Product Change Notification / GBNG-12EUHF585

CCB 4635 Initial Notice: Qualification of MMT as a new assembly site for selected Atmel AT27C040, AT27C080 and AT27LV040A device families available in 32L PLCC (11.5x14x3.37mm) package.

CCB 4635
Pre and Post Change Summary
PCN #: GBNG-12EUHF585

Lead frame Pre and Post Change

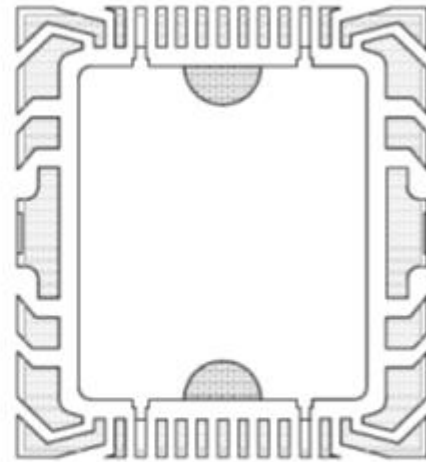
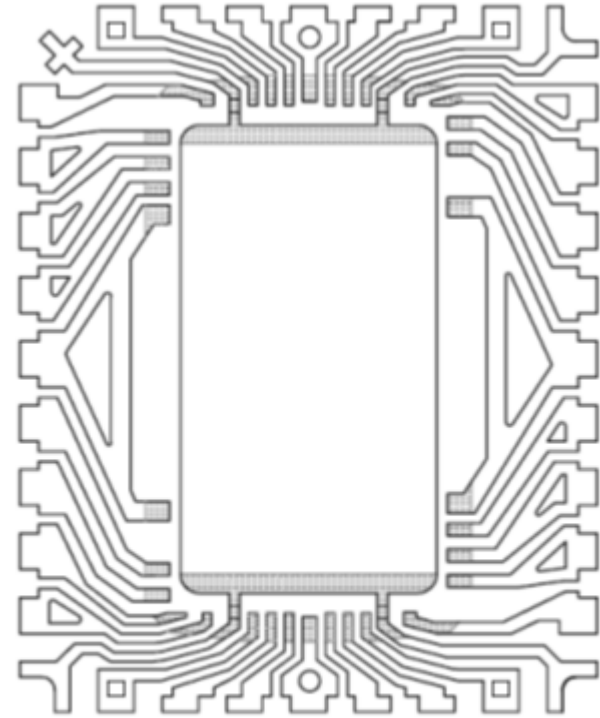
PAD SIZE:200x365 MILS
FUSED LEAD ON PIN#16

PAD SIZE:225x260 MILS
NON-FUSED LEAD ON PIN#16

PAD SIZE:200x365 MILS
NON-FUSED LEAD ON PIN#16
